LARGE WOODY DEBRIS MANAGEMENT PLAN SETTLEMENT AGREEMENT ARTICLE 109

BAKER RIVER HYDROELECTRIC PROJECT
FERC No. 2150

January 2011

Figure 1. Baker River Hydroelectric Project, Concrete, Washington.

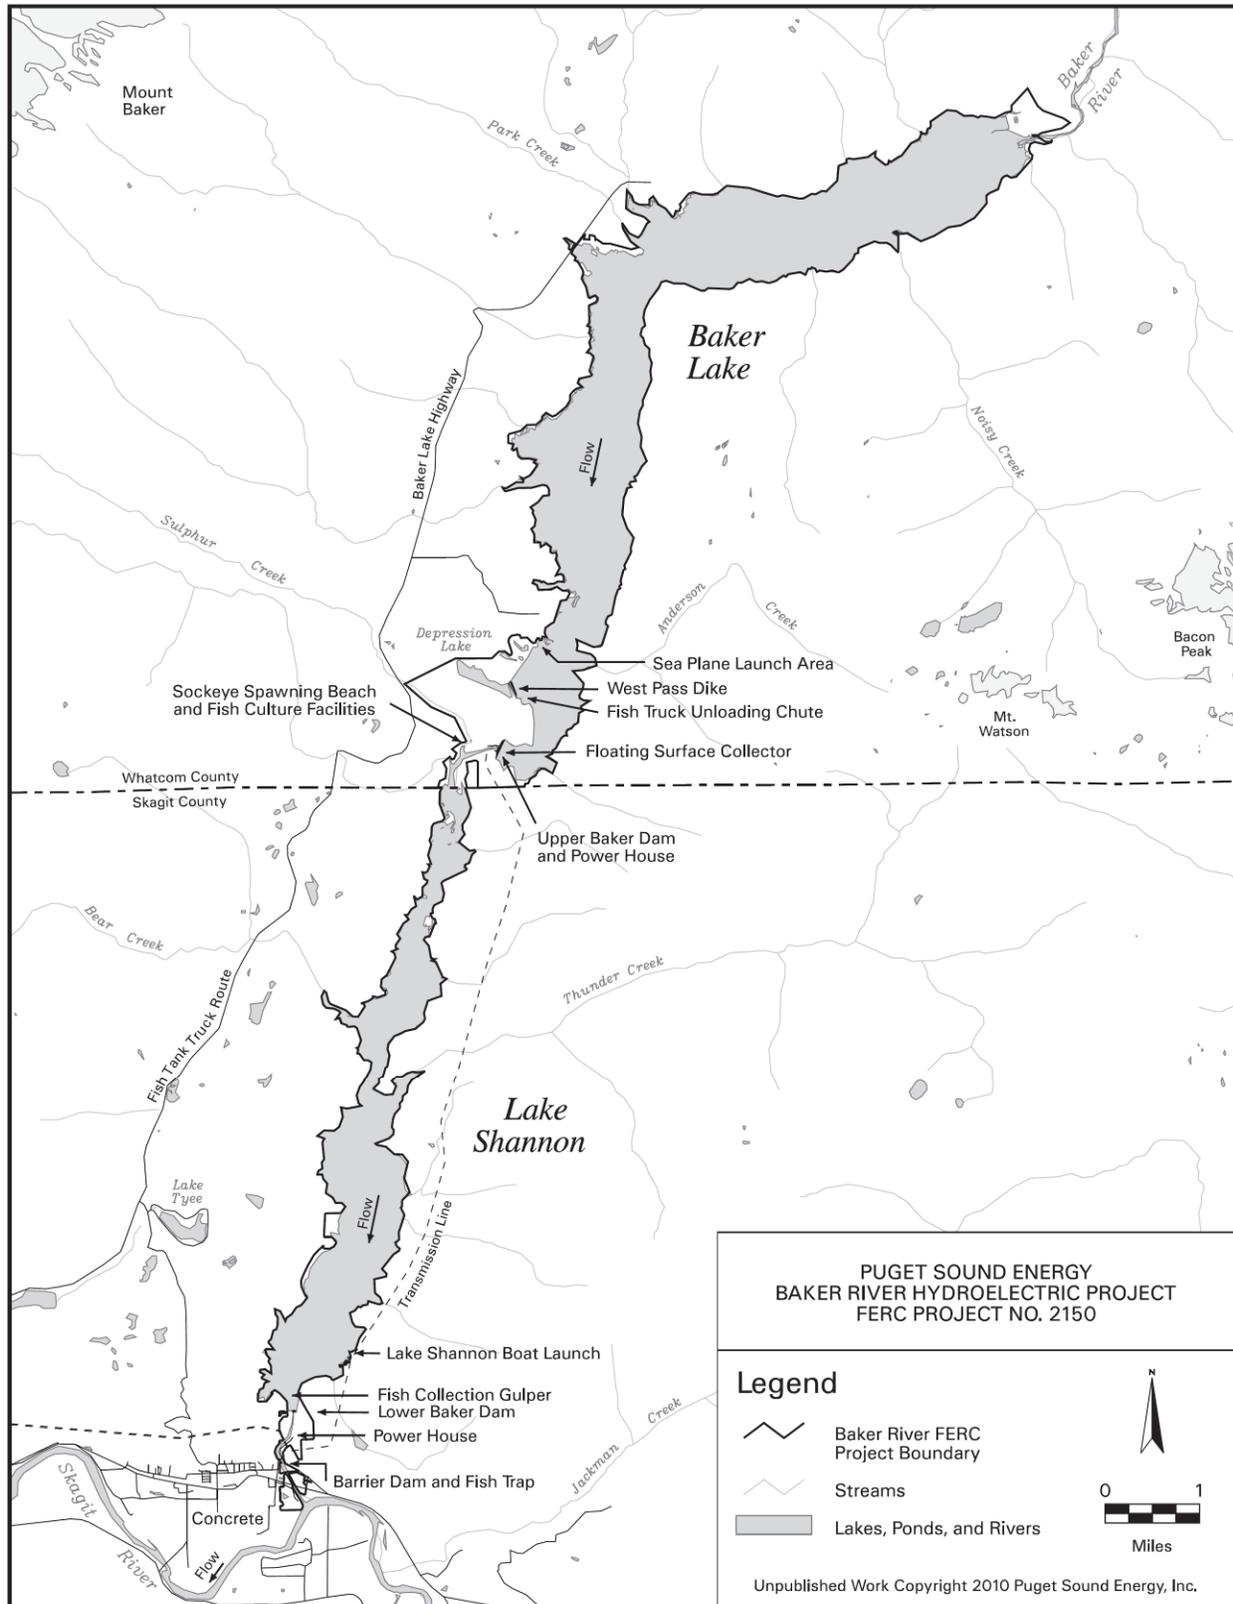
6.5.2 Collect and Transport LWD Page 11: "PSE has identified the sea plane launch area within Baker Lake and a cover near Lake Shannon boat launch." Please label figure one with Lake Shannon location, near boat launch is ambiguous.

<p>6.5.2 Collect and Transport LWD Page 11: "PSE has identified the sea plane launch area within Baker Lake and a cover near Lake Shannon boat launch." Please label figure one with Lake Shannon location, near boat launch is ambiguous.</p>	<p>The exact location and perimeter of the Lake Shannon LWD stockpile site has not yet been identified. As stated in section 6.5.3, the location of proposed stockpile areas will be provided to the ARG and TRIG for review and comment within one year of FERC approval of the LWDMP. The construction staging area for the Lake Shannon downstream fish passage facility will be located near the boat launch and is a possible location for the long-term LWD stockpile site. Given the scale of figure 1, the arrow and label for the boat launch specifies the general location of the LWD stockpile site. No revisions to plan.</p>
<p>6.5.3 Stockpile and Inventory LWD Page 11: "The LWD stockpile areas will be inventoried each year to record number, size, species and condition of available for use by other parties." Please consider removing all use of "other parties" to settlement signatories' or something similar to reflect only agencies that have signed the Settlement Agreement can access this resource.</p> <p>"PSE will maintain a separate tally of the number and size..." Please consider recording and accounting of LWD removed from stockpile by agency, project type, and location of project.</p> <p>"LWD pieces intentionally allowed to remain in place..." see comment on 6.5.1 page 10 above.</p>	<p>The phrase "by other parties" has been deleted without replacement in all sections of the plan.</p> <p>PSE will inventory wood within the stockpile site, implement measures to prevent theft, and allow the loading and removal of wood. Use of the stockpiled wood is under the direction and responsibility of the ARG and TRIG and is beyond the scope of SA 109.</p> <p>See previous response to comment 6.5.1.</p>

Figure 2. Process flow chart for the Large Woody Debris Management Plan, SA 109.

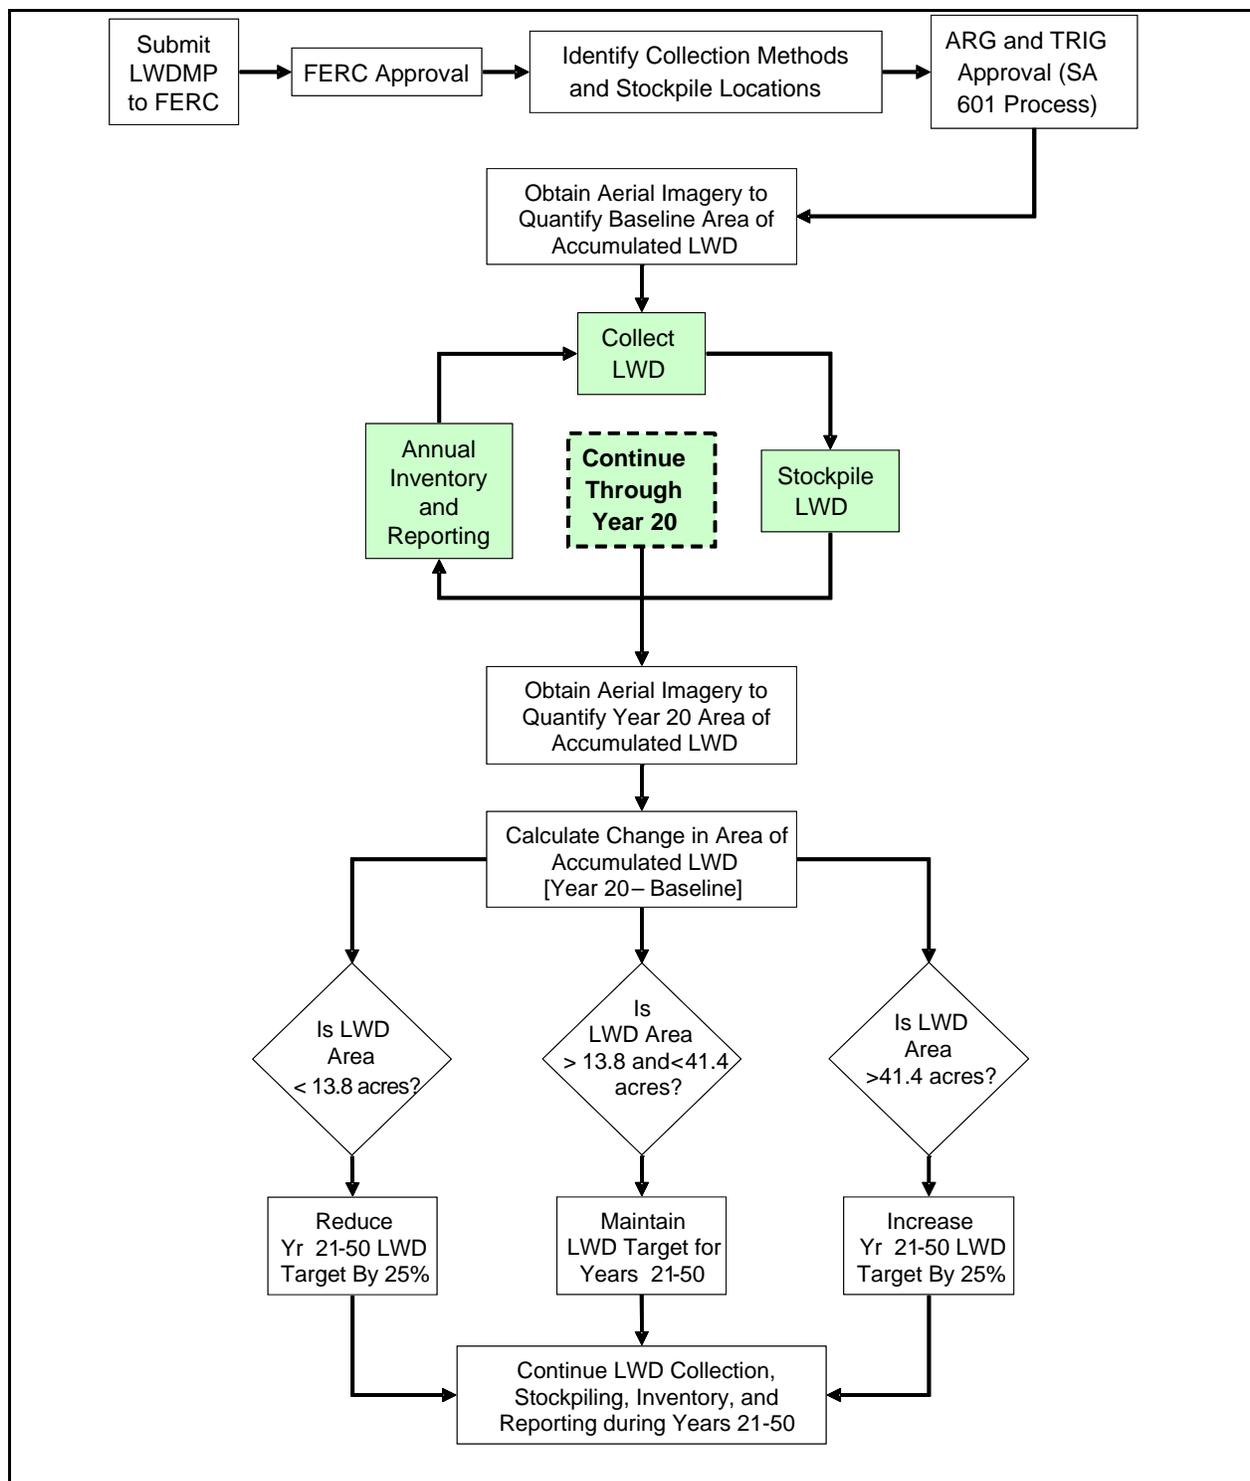
Figure 2 Page 14: Please incorporate changes described at Nov. 9, 2010 ARG meeting.

Comment	Puget Sound Energy Response
Figure 2 Page 14: Please incorporate changes described at Nov. 9, 2010 ARG meeting.	As discussed at the ARG meeting, target acreage values for Year 20 LWD accumulations were revised, and references to LWD size classifications will use 30-60 cm, 60-90 cm and > 90 cm and avoid "small," "medium," and "large" terminology.
